ITEM 9.5.1  
APPENDIX A

PROPOSED LOCATION  
OF SHED 6X5 FOR  
SIMON J. NEVILL.  
BLANDSTOWN HERITAGE  
PRECINCT

## Schedule of Submissions

Site Plan

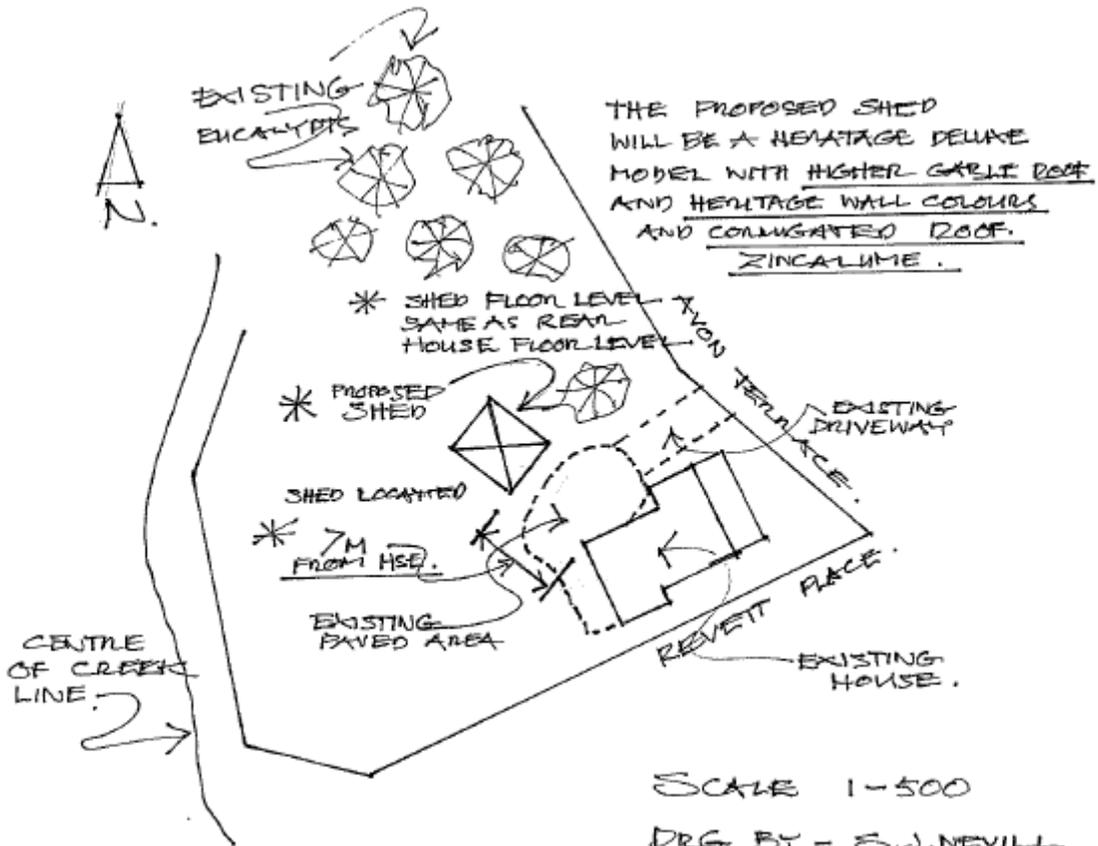
<p>because it will greatly reduce impact on the streetscape.</p> <p>5. <u>Alignment</u> of the shed should be square-on to the footprint of the cottage to unify all site structures visible from Avon Terrace.</p> <p>6. <u>Proposed colours</u> are appropriate and described as “heritage” for the walls but should be either heritage red (to complement the zinc CGI on ref brick of the cottage) or dark heritage green (to match the existing shed) and without contrasting coloured trim to make it less obvious from the streetscape.</p> <p>7. <u>Permitted use</u> should be consistent with normal use within a residential zoned area.”</p>	<p>7. Agreed. Standard shed use condition recommended.</p>
--	--	--	--
